Docket Item # 3 & 4 BAR CASE # 2018-00343 & 2018-00344

BAR Meeting September 19, 2018

ISSUE: Partial Demolition/Capsulation and Addition and Alterations

LOCATION: 609 South Lee Street

PROPOSED FRONT YARD PLAN

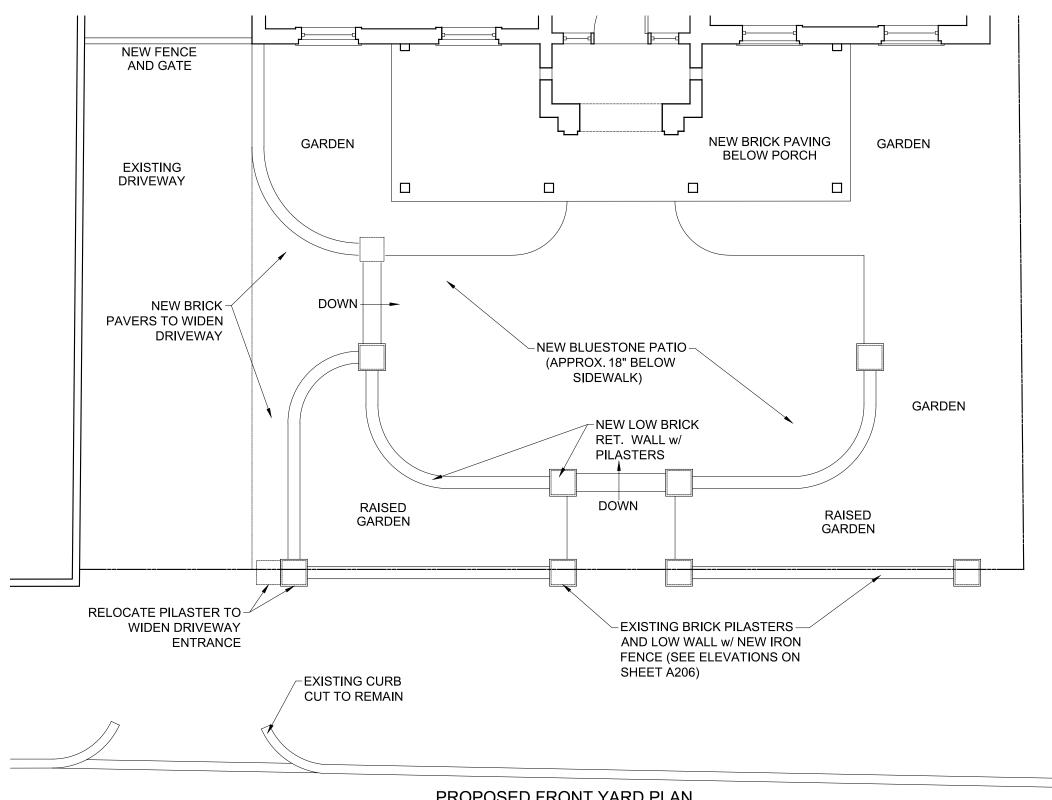
- C-1 Proposed rear stoop/stair shown on C103 is located in the required side yard, but is not shown on other pages of the plan set. If greater than 2' in height, not a permitted obstruction in the required side yard. Submit revised elevations indicating height and revised page SP101 to show on plat.
- C-2 Proposed repairs/replacement fence and pillars are in the public right of way and are not direct replacements. Consult with TES to determine if an encroachment is required. (T&ES staff confirmed that an encroachment is not required).

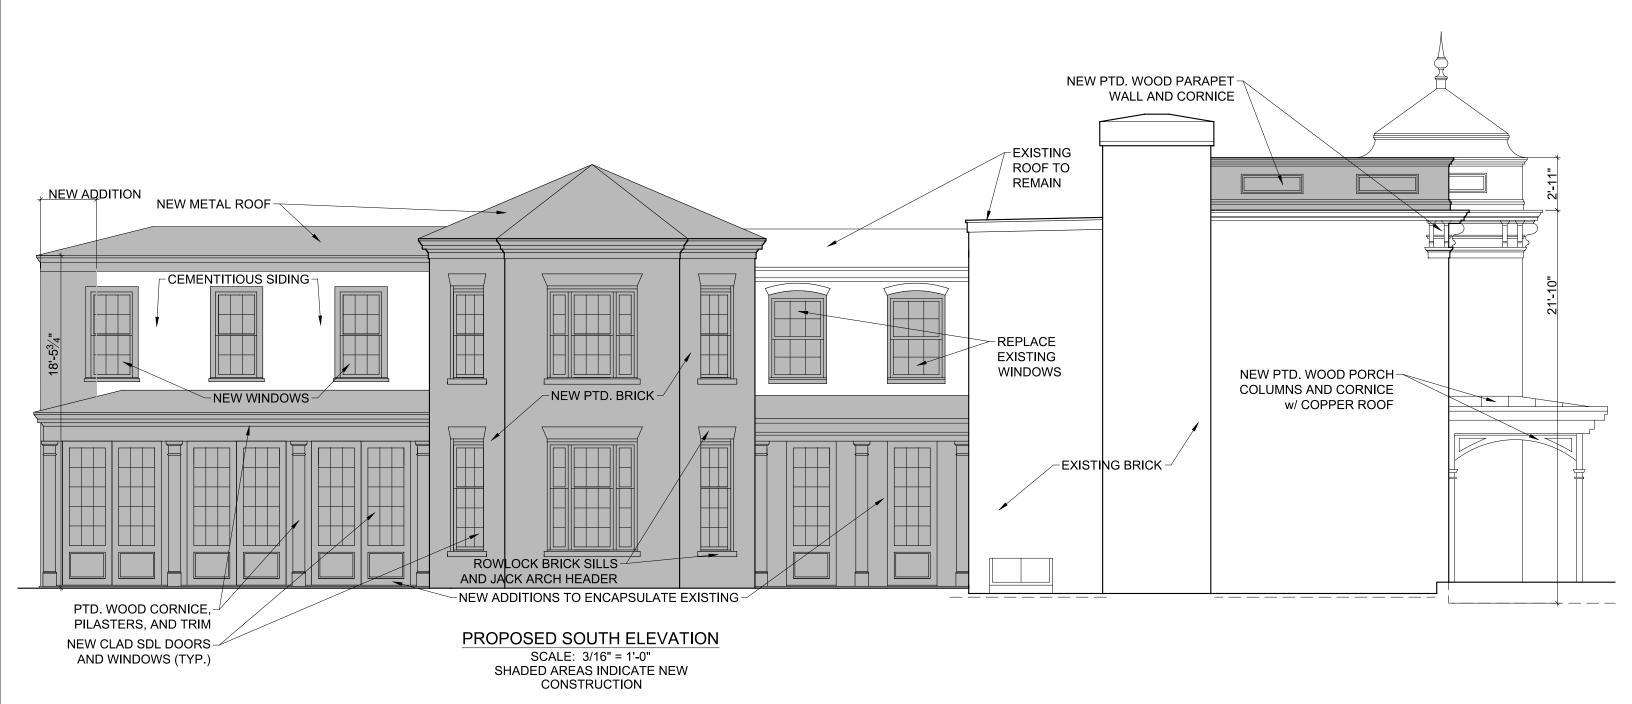
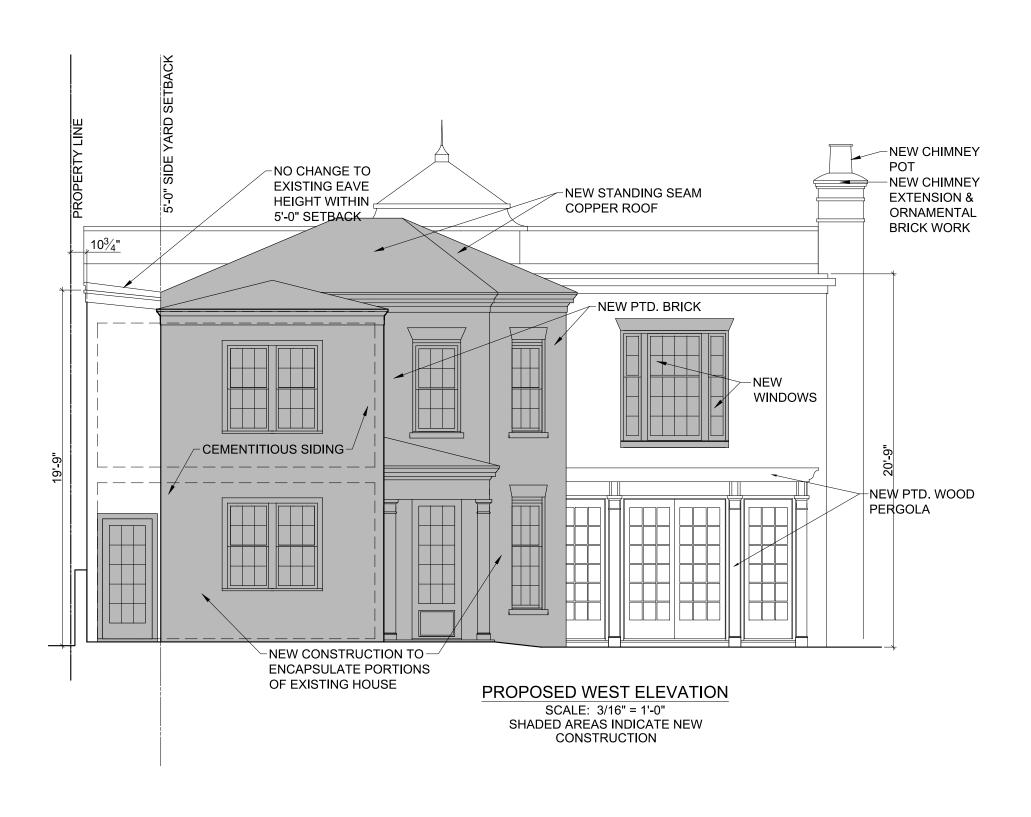
- 1. Work with staff to restudy the roof form of the central turret above the front entrance to lower or eliminate the pyramidal roof and finial and to retain the existing front cornice.

- 2. Construct the new parapet/rooftop mechanical screen of brick to match the wall below, rather than wood. Work with staff on the final details of the recessed panels and coping.

Finally, the pyramidal hip roof and finial over the main entrance has been a lightning rod (pun intended) with some staff and community members finding it too high-style for this house in this location. While the pyramidal hip roof is an appropriate architectural form found on many Victorian period and some new dwellings in Old Town (Figures 8&9)

Staff finds architectural value in the upper portion of the pyramidal roof as a way to reinforce the overall visual hierarchy of the façade and to identify the location of the primary entrance and supports this feature but recommends that the lower portion, or sloping base, of the two-step pyramidal roof and the finial be eliminated to make this feature more visually quiet and less competitive with nearby historic dwellings.
